Quest CCS Project

Independent Project Review (IPR) of Storage Component of the QUEST Carbon Capture and Storage Project

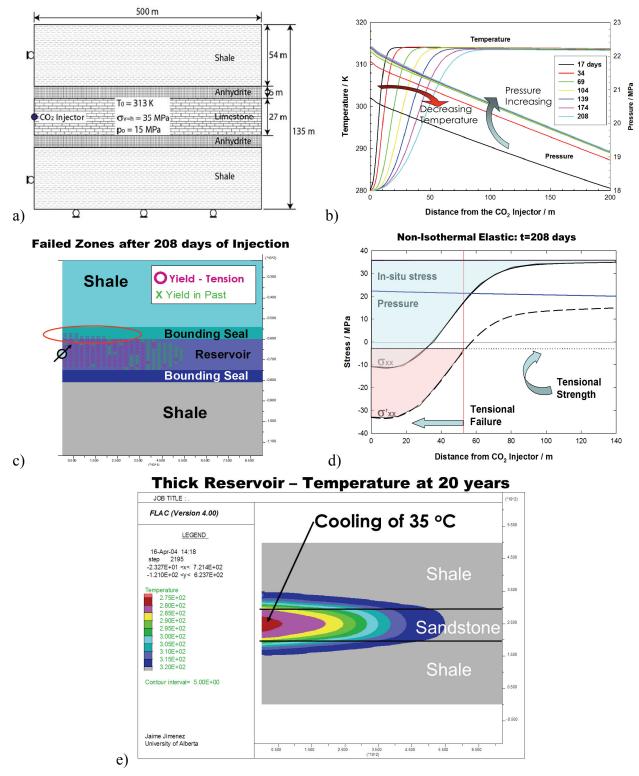
Risk 4163, 4342, 4503 and 4164: Probability and impact assessments appear to be within the range of reasonable uncertainty. For Risk 4342, the intimate link to the MMV plan that will be developed over the next 6-9 months is critical to managing this risk. As Gen-4 modelling proceeds in concert with the refinement of the MMV plan, it is recommended that more quantifiable estimates of the ranges of the "indicators" identified for each monitoring task included within the MMV plan (as described in Table 7 in the MMV Plan Report). It is understood that history matching and model updating will be an on-going process during injection in order to evolve the predictive confidence in preparation of post-closure and liability transfer. Predicting the degree of departure from the expected behavior of the storage complex is an important element in this history matching process and provides a defensible rationale for the implementation of additional MMV technologies if there is a departure from the expected behavior.
